ADDENDUM NO. [2]

Date: September 17, 2019

**RE: SCHOOL DISTRICT OF LA CROSSE
7 RIVERS CHARTER SCHOOL
225 5TH AVE SOUTH
LA CROSSE, WI 54601
HSR 19003**

14. Sheet A200 EXTERIOR ELEVATIONS AND BUILDING SECTIONS 30 x 42 attached hereto

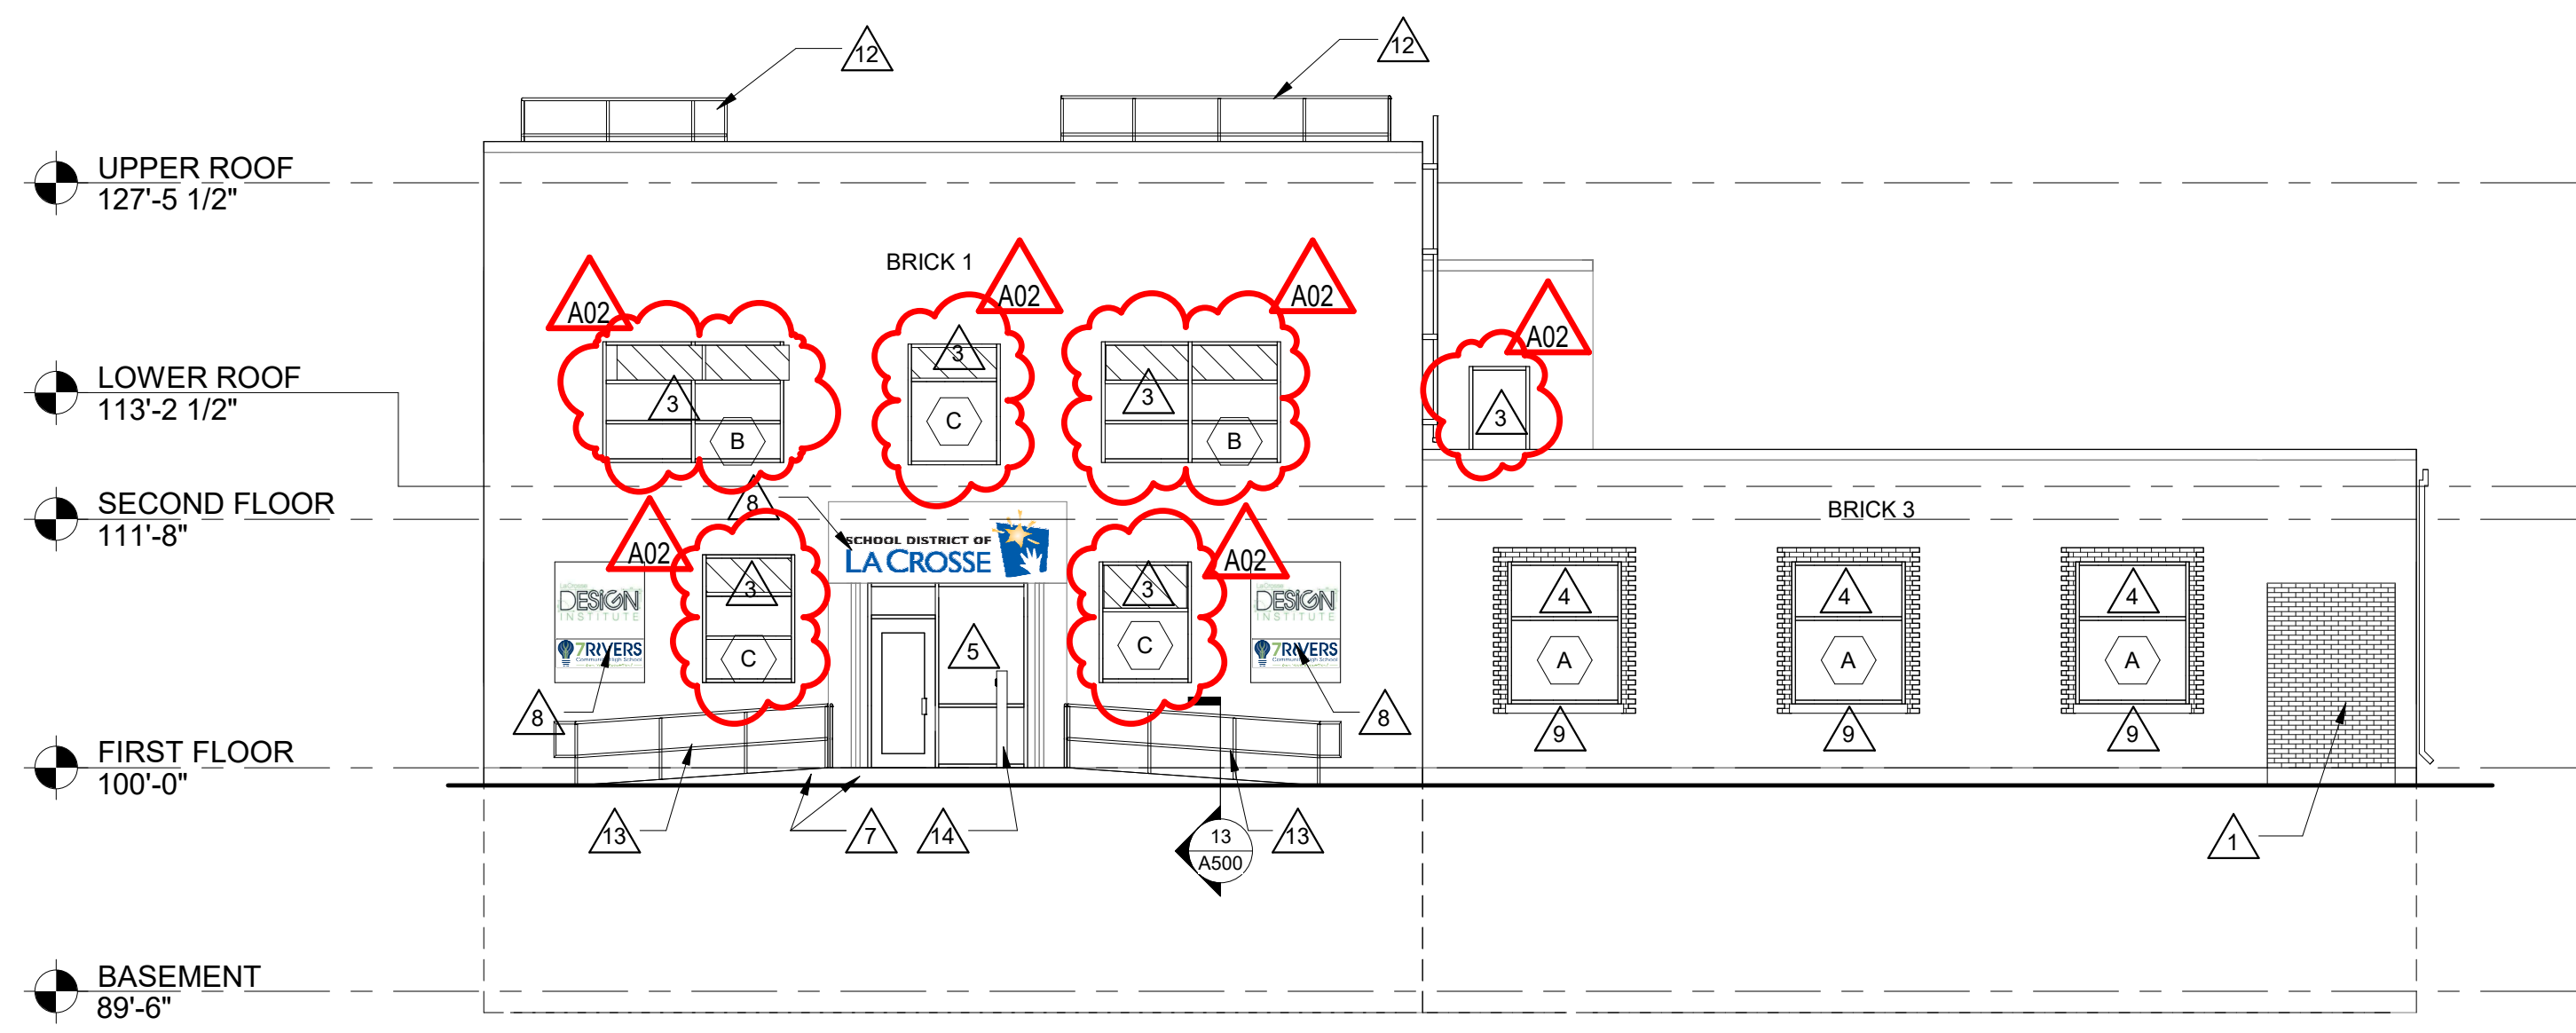
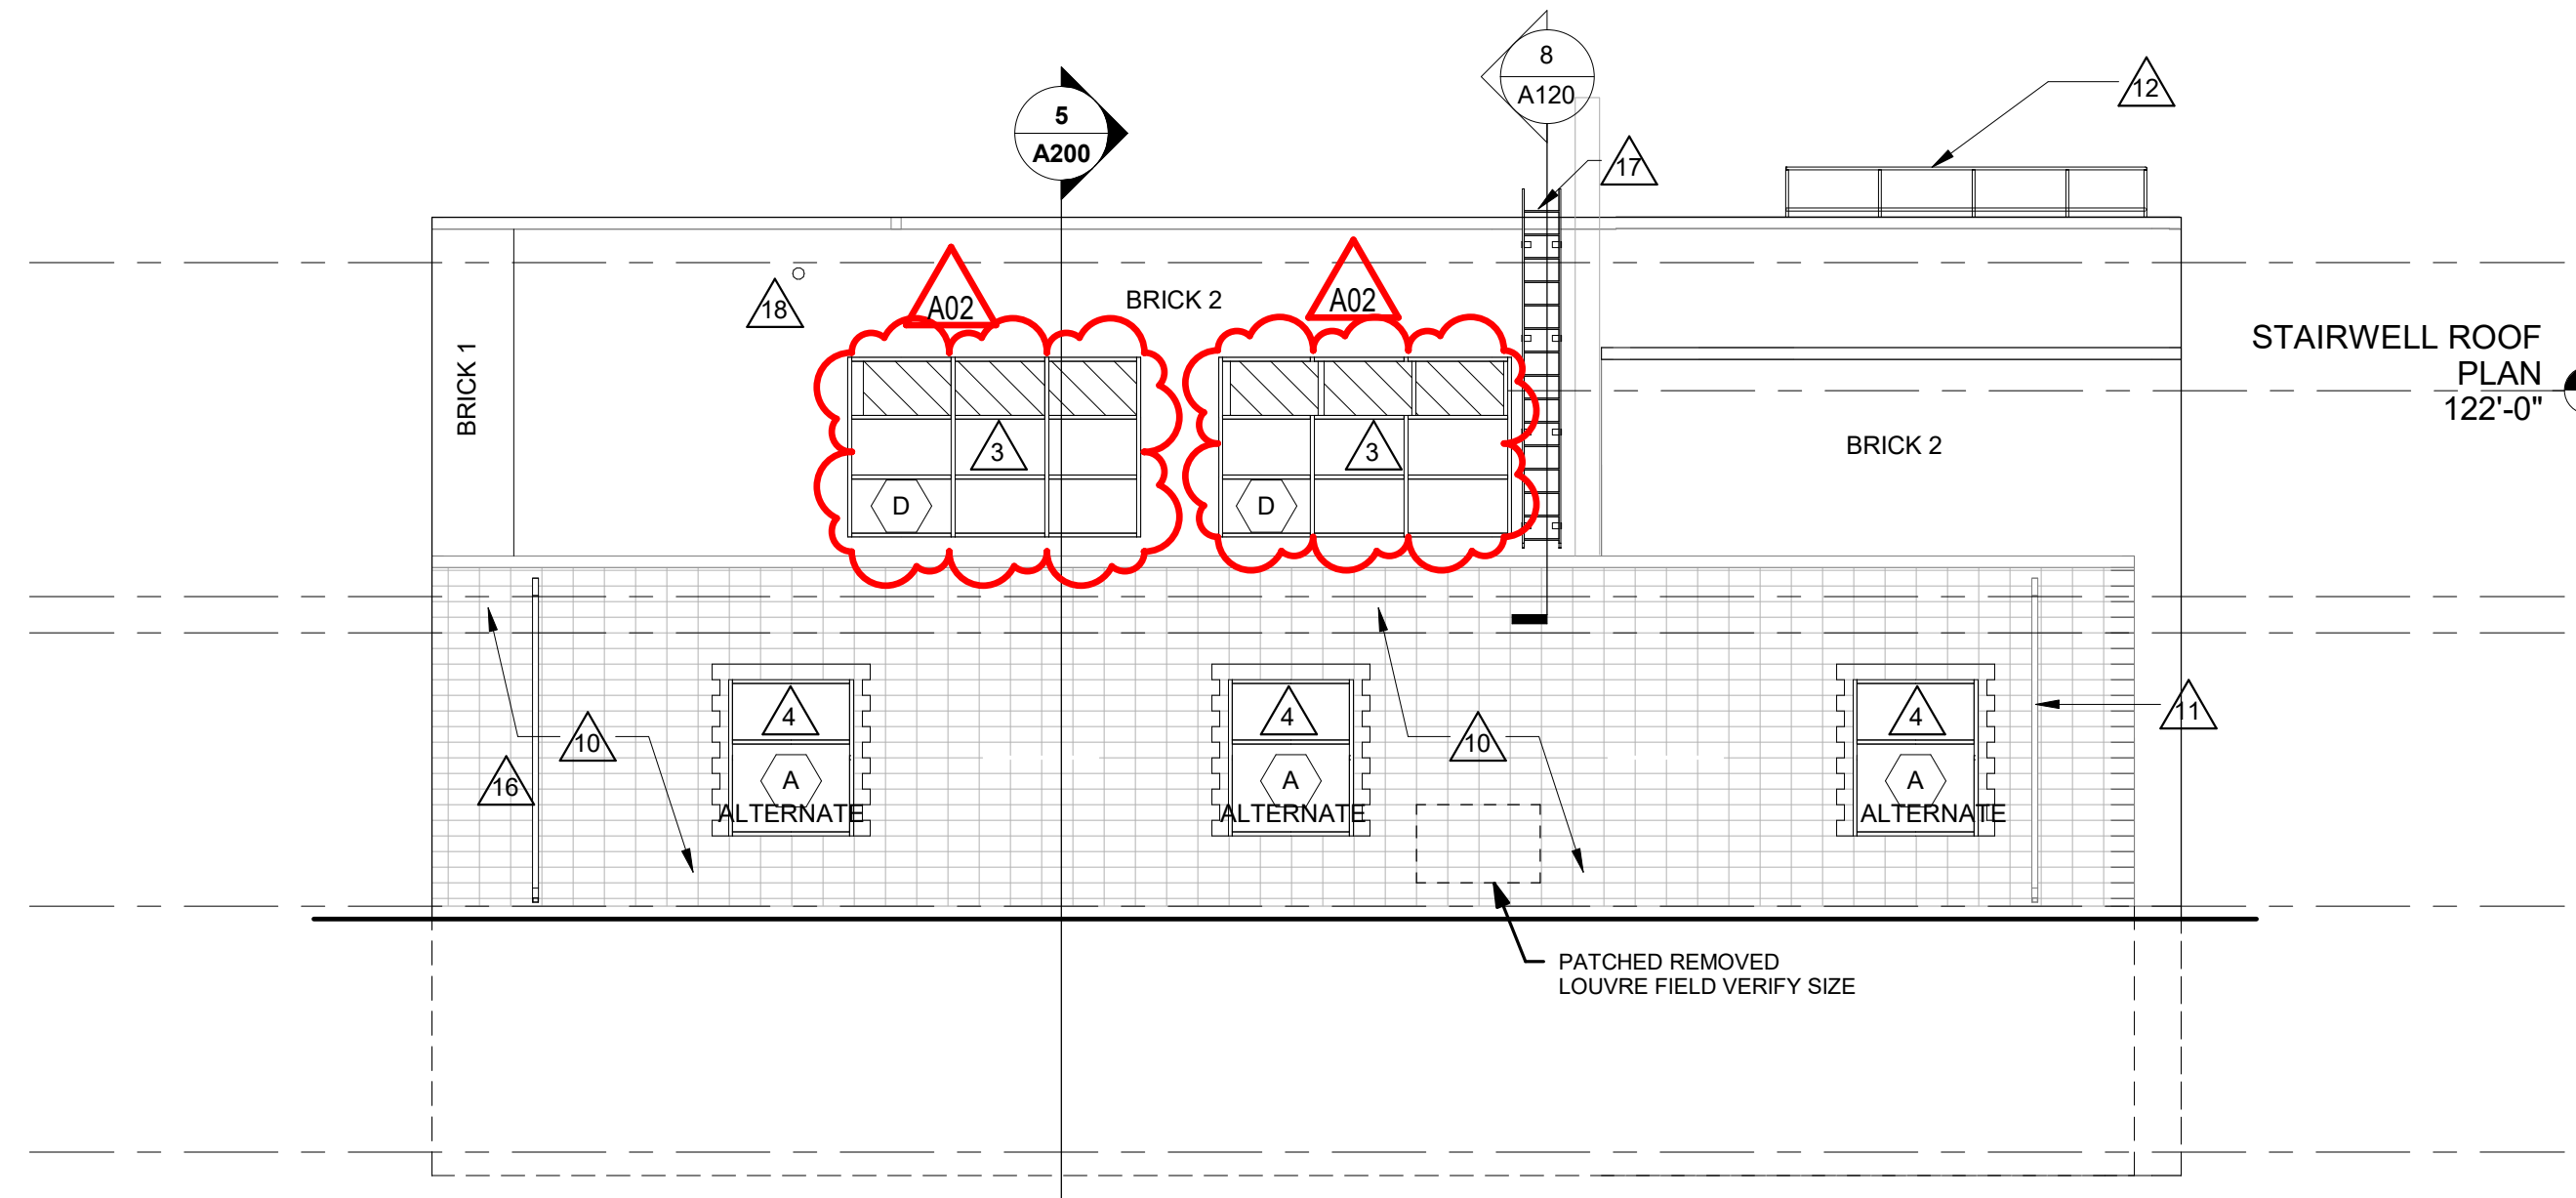
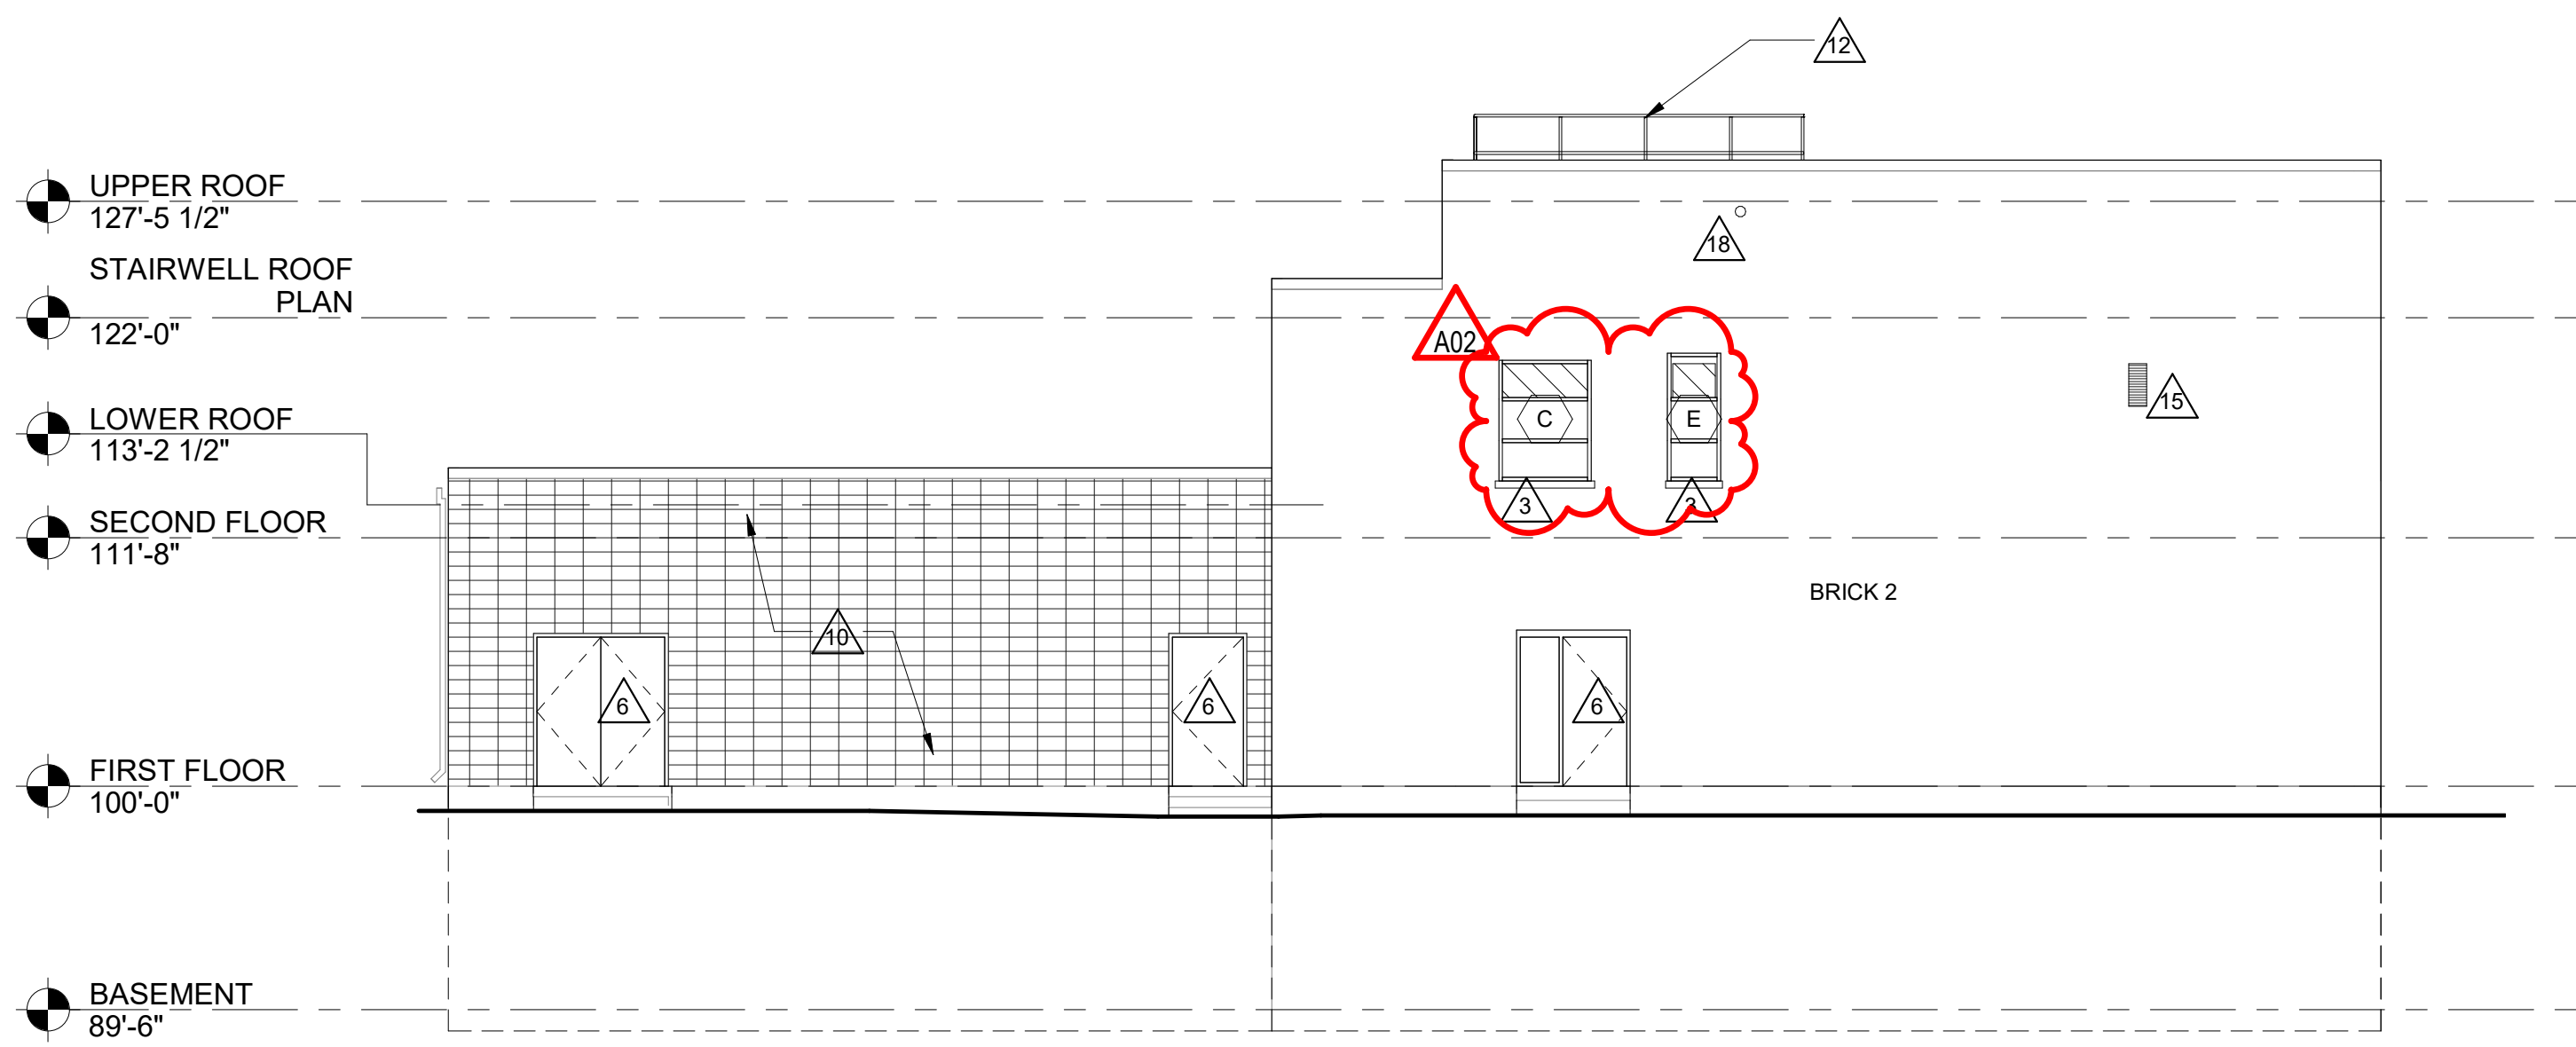
- a. Revisions clouded on Drawing.
- b. New windows shown.
